Notice of Intent

Type of Action: Plug and Abandonment

HILCORP ENERGY COMPANY
NV KEVIN 23 2
NOTICE OF INTENT TO PERMANENTLY ABANDON

CONDITIONS OF APPROVAL

NV KEVIN 23 2 - PROPOSED P&A SCHEMATIC

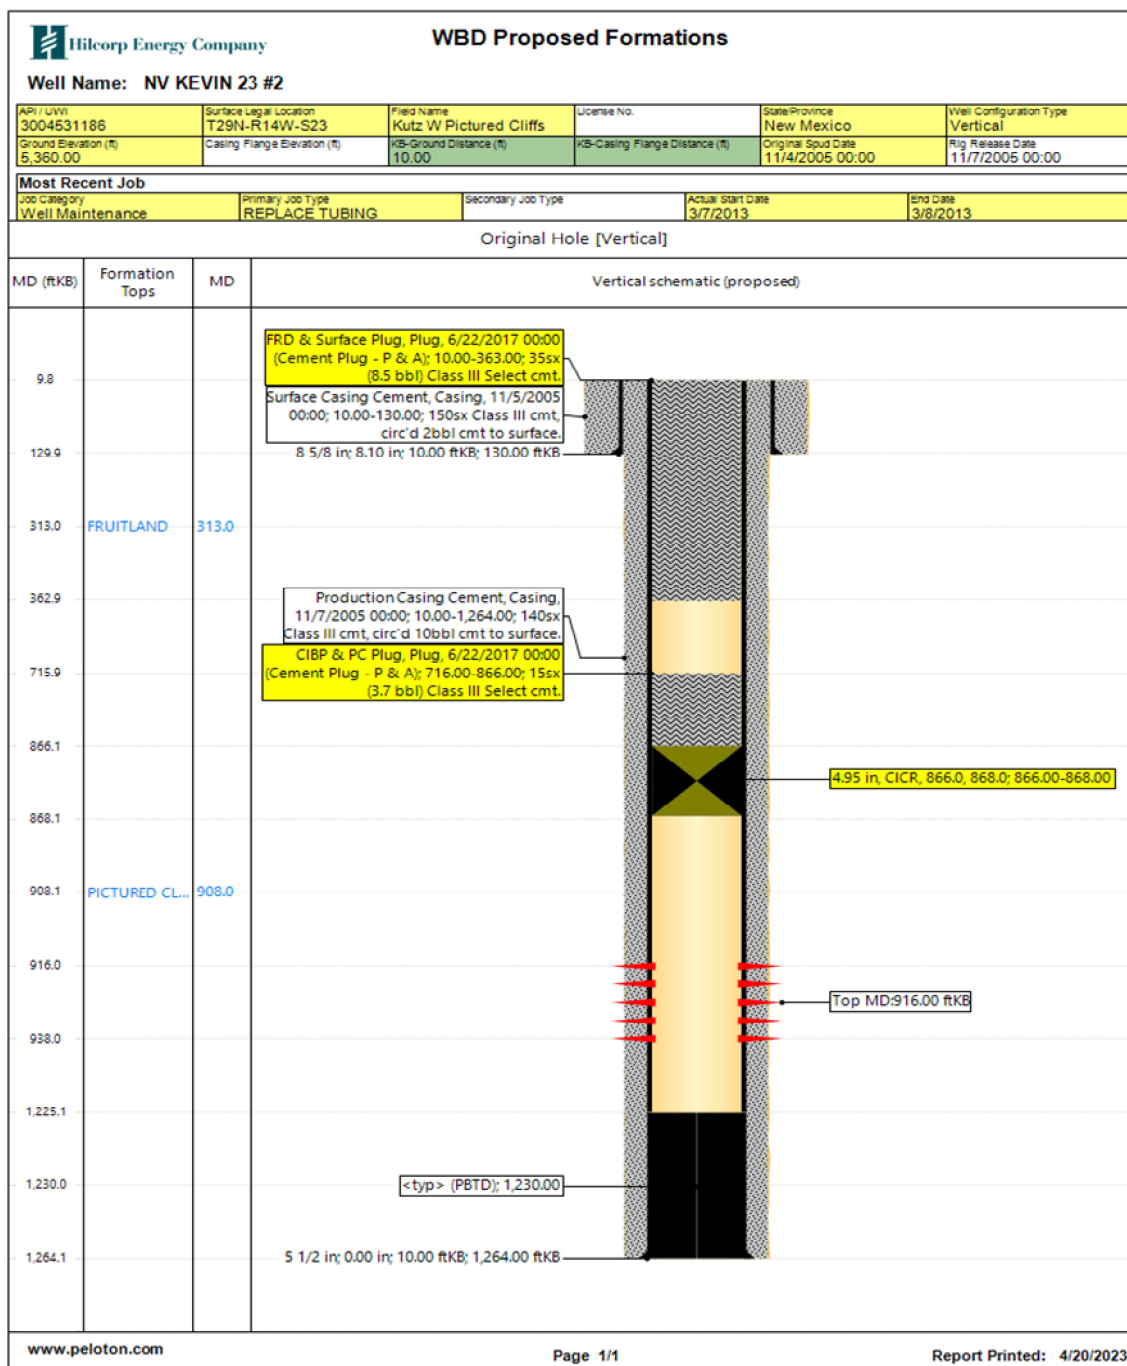
1. Plugging operations authorized are subject to the attached "General Requirements for Permanent Abandonment of Wells on Federal and Indian Lease."
2. The following modifications to your plugging program are to be made:
 - a. Adjust Plug #2 (Fruitland/ Surface), or add a plug, to cover BLM Fruitland top @ 458'.
3. Farmington Office is to be notified at least 24 hours before the plugging operations commence at (505) 564-7750.

- Pictured Cliffs perms 916' - 938'.	1) Formation Tops Same
- Adjust Plug #2 (Fruitland/Surface), or add a plug, to cover BLM Fruitland top @ 458'.
